Board of Zoning Appeals Division III

Case Number:	2026-DV3-011
Property Address:	3603 South Meridian Street (<i>approximate address</i>)
Location:	Perry Township, Council District #18
Petitioner:	Roman Catholic Archdiocese of Indianapolis, Properties Inc as Trustee for St Roch, Catholic Church Indianapolis Inc., by Wooton Hoy (John Cross)
Current Zoning:	SU-1 / D-4
Request:	Variance of Development Standards of the Consolidated Zoning and Subdivision Ordinance to permit an 8-foot fence in the front yard (fences taller than 4 feet not permitted in front yards) and located within the clear sight triangle (not permitted).
Current Land Use:	Developed, School
Staff Recommendations:	<u>Staff recommends approval of the variance for fence height.</u> <u>Staff recommends denial of the variance for obstruction of the clear sight triangle.</u>
Staff Reviewer:	Josh Levesque, Manager

2026DV3011; Site Plan (2)

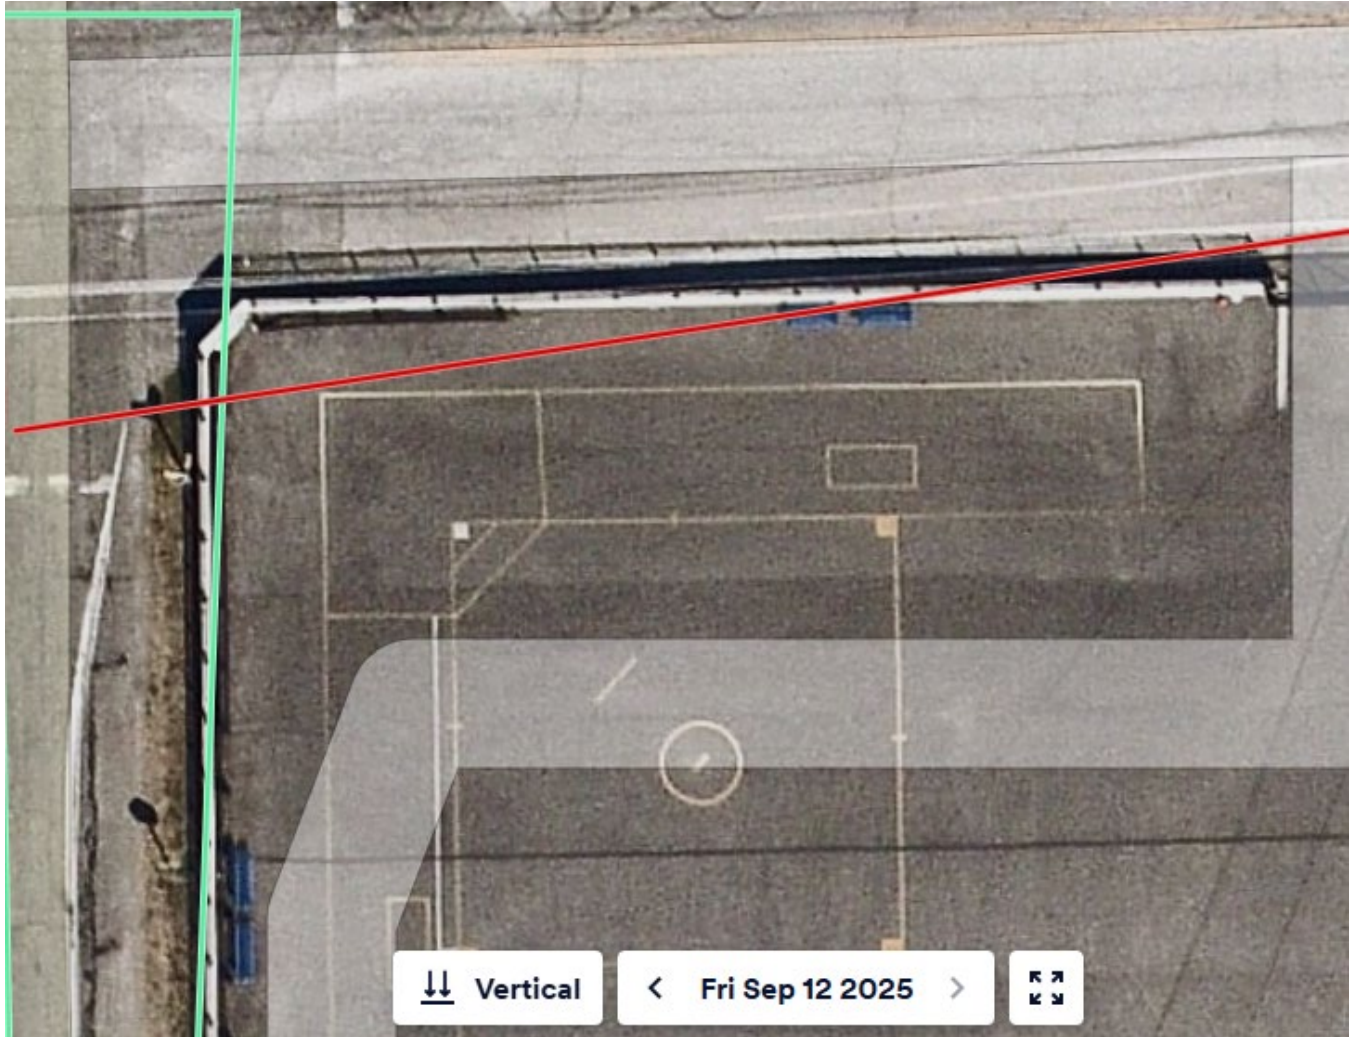
- Petitioner's updated plans propose to clip the fence on the northwest corner and bring it partially within the clear sight triangle. However, the petitioner's own diagram shows that the fence/wall will still partially encroach into the clear sight triangle. The clear sight triangle is intended to promote safety and to reduce traffic conflicts—a chief concern near schools.

are sidewalks, traffic stop bars, and turn lanes. Obstructing these presents potential hazardous conditions for area pedestrians and drivers. The petitioner can keep students AND the public safe by lessening the amount of lot they used and moving the fence/wall outside the clear sight triangle. Such an action would also create greater separation from the pay area and the street, further helping to increase safety.

2026DV3011; DPW Clear Sight Diagrams (2)

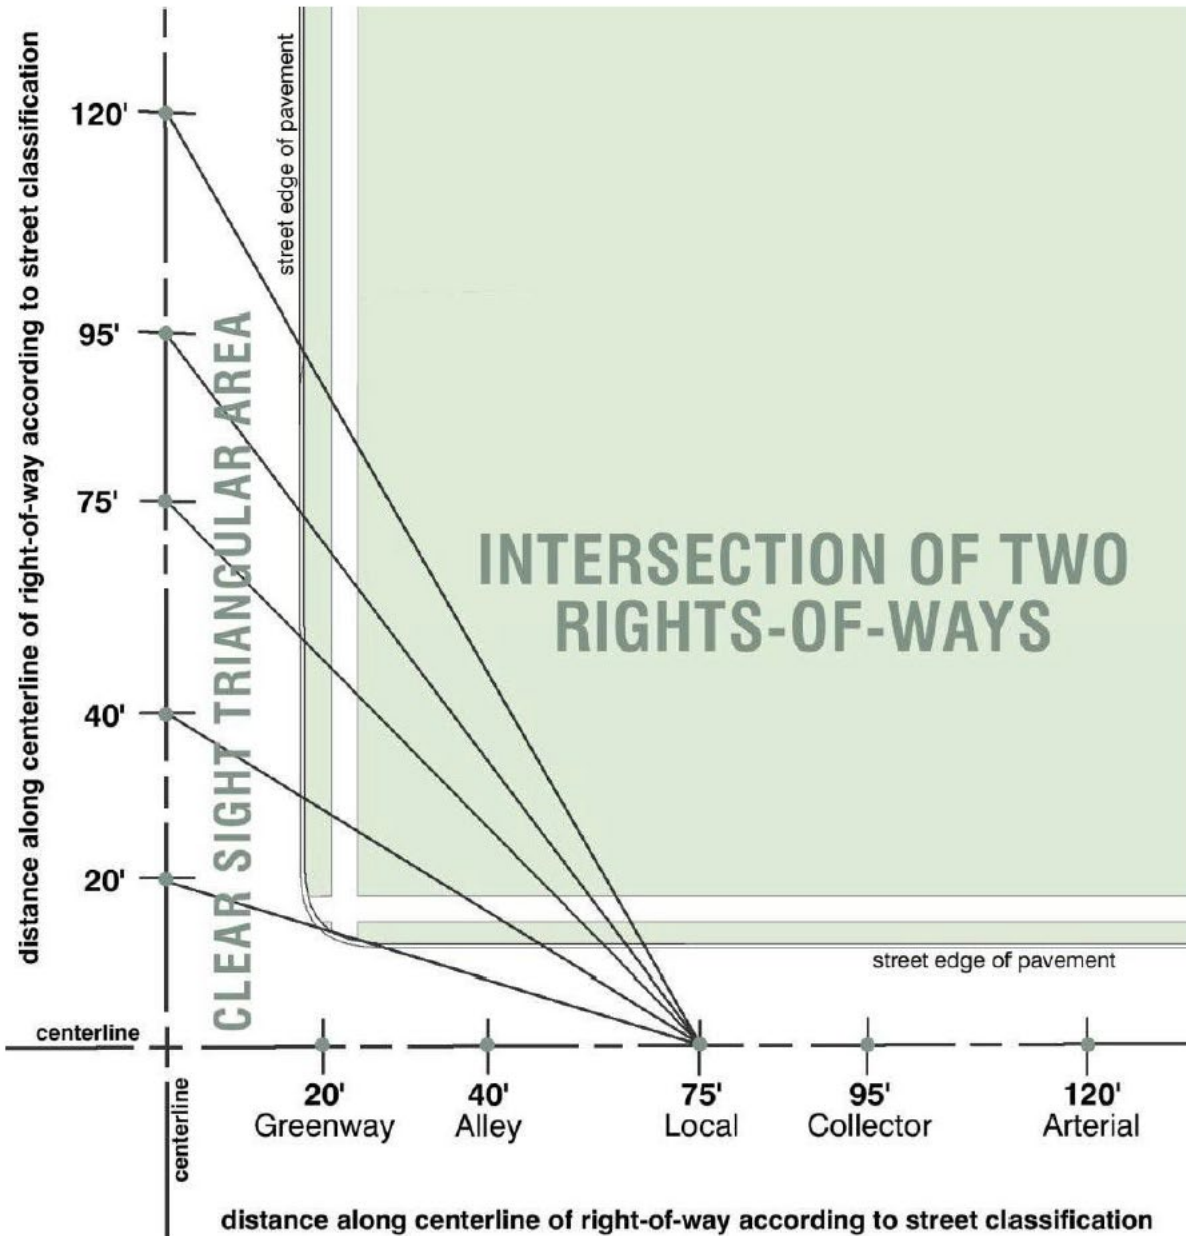
- 744-503.H of the Ordinance indicates that "no obstructions shall be erected, placed, planted, or allowed to grow in such a manner as to materially impede visibility between the heights of 2.5 feet [30 inches] and 8 feet above grade level." The Department of Public Works also relies on sight triangles (an engineering sight triangle) to determine the safety of intersections. The clear sight triangle used by DPW represents the area a driver needs visibility in order to react and stop in case of an oncoming hazard. It also represents the distance the driver needs to see oncoming traffic from the left and right so they can safely pull into traffic. Furthermore, an obstruction into the clear sight triangle impedes a driver's ability to see pedestrians. Pedestrians, whether waiting at the corner or attempting to cross the street would be in particular danger. The diagrams below (see "Clear Sight Diagrams" in "Exhibits") show the extent to which the fence/wall encroach into the clear sight triangle.
